MFN 08-050

Subject: Response to Portion of NRC Request for Additional Information Letter No. 119 Related to ESBWR Design Certification Application – Human Factors Engineering - RAI Numbers 18.8-2 S01, 18.8-8 S02, 18.8-16 S02, 18.8-17 S02, 18.8-18 S02, 18.8-31 S02, 18.8-32 S02, 18.8-33 S02, 18.8-35 S02, 18.8-41 S02, 18.8-49 S02 and 18.8-50 through 18.8-59

**Response to NRC Request for Additional Information
Letter No. 119 Related to ESBWR Design Certification
Application Human Factors Engineering**

Figure 2 Human-System Interface Design Implementation Process

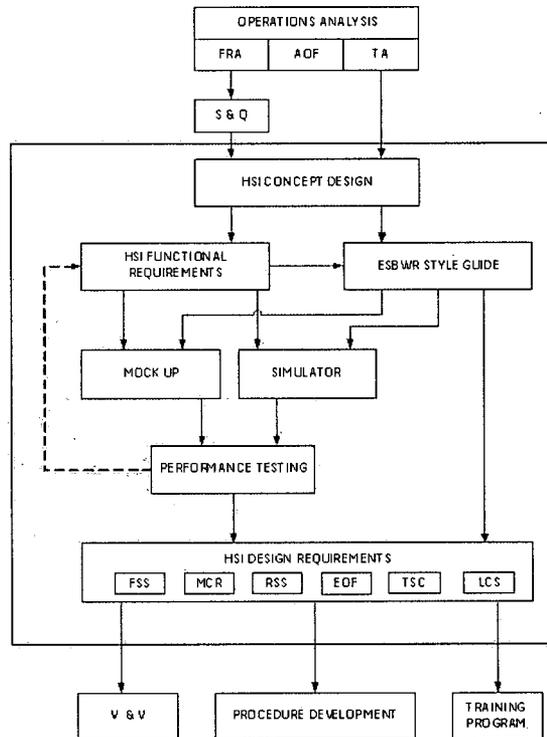
NEDO-33268, Figure 2 lists a number of design inputs. Questions related to some of them are:

In the original RAI, the Staff requested clarification of Figure 2 of NEDO-33268, Revision 0. GEH provided clarification in their response to RAIs of the staff's questions concerning the Figure. GEH indicated the NEDO would be revised to include the clarifying material, but it was not included. These clarifications included revising NEDO-33268 to establish the preparation of the ESBWR Human Factors Guidance Manual to include the guidance for HSI design from the RAI response (Note: Figure 2 is now Figure 3). These clarifications should be included in the next revision.

These questions clearly inquire about the contents of the first box in Figure 2. Human factors engineering takes a systems approach to the evaluation of tasks, situations, interfaces, or environment. Thus these are standard commonly known elements or contributing variables of systems, particularly related to the nuclear industry. These elements all bare information regarding the human in the system and each lends information about that system and the persons within the system.

NEDO-33268 will be revised to establish the preparation of the ESBWR Human Factors Guidance Manual to include the above guidance for HSI design.

To follow the guidelines regarding functional requirement specification as described in NUREG-0711, the team will follow the process illustrated in Figure 2 of NEDO-33268:

The HSI work instructions provide the methodology.

Figure 5 Appropriate Data Collection Methods for HFE Activities

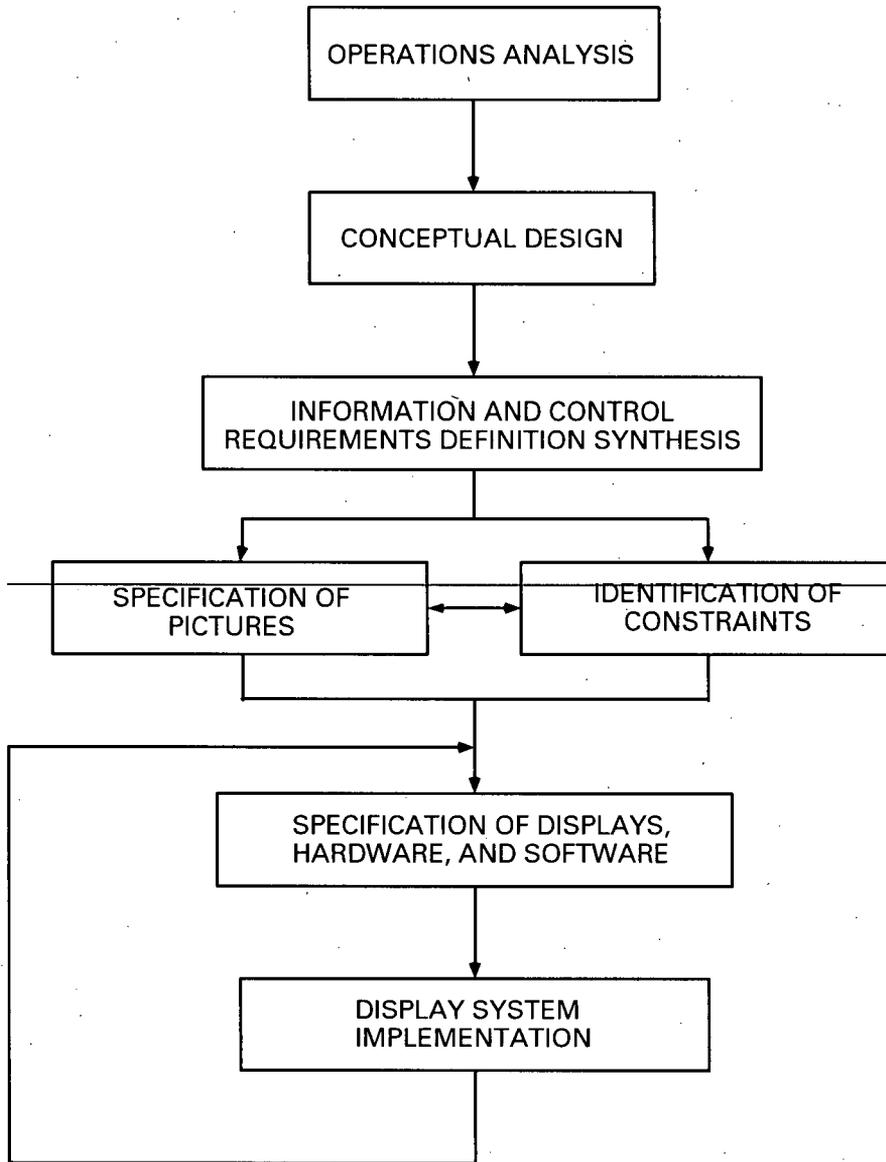
Figure 4 clarification - NEDO-33268, p. 95, Figure 4 lists HFE activities across the top of the matrix. Why were these activities chosen? What is meant by performance models? How are MMI Evaluation and Evaluation of Alternative Designs different? How were the ratings in the cells of the table determined?

In the original RAI, the staff requested clarification of the HFE activities listed in Figure 4 of NEDO-33268, Revision 0. GEH's response indicated that the plan would be revised for clarification and that the "Table" (Figure 4?) would be eliminated. However, the clarification has not been provided and the figure remains in the plan (now Figure 5). Please clarify.

These are standard activities that are evaluation tools within the profession of human factors engineering that were used in the evaluation of the Lungmen human-computer interface design. However newer procedures and evaluation tools have been developed that GE plans to use in the design of the ESBWR plant such as:

NEDO-33268 will be revised and this table will be eliminated. GE will provide descriptions of the procedures and evaluation tools used to design the HSI features of the ESBWR.

To the degree possible the test design minimizes bias, confounds, and error variance (noise). ~~Test data is collected using appropriate techniques such as those shown in Figure 5.~~ Design solutions are developed to address problems that are identified during the testing and evaluation of the HSI design.

Figure 6 Levels of Design and Evaluation

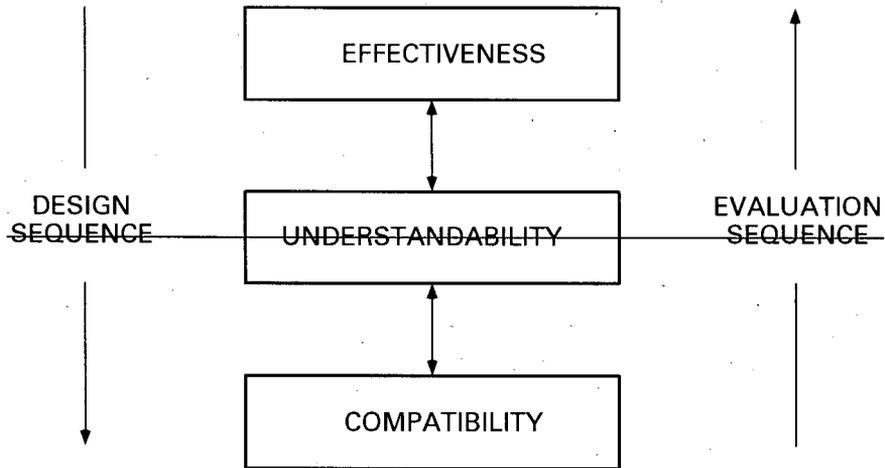
In the original RAI, the staff requested clarification of the methods of evaluation to be used. The descriptions of the methods of evaluation from the original RAI are now on Pages 37-38 of NEDO-33268, Revision 2 and have been slightly abbreviated. The same need for clarification still exists. The section still does not describe how a user of the document conducts the evaluations. Also, the lead-in paragraph references Figure 6, but Figure 6 does not address methods of evaluation. In Revision 0, the same paragraph referenced Figure 7, which did illustrate how multiple methods of evaluation can be sequenced, but this Figure has been removed in Revision 2. Please clarify.

~~Figure 6 illustrates how multiple methods are sequenced to pursue the evaluation issues. This figure is not meant to imply that all five types of evaluation (that is, electronic, paper, part task, full scope, and in plant) are required for every evaluation effort. The methods employed first are those that are relatively fast and inexpensive and that can be employed earliest in the design process.~~
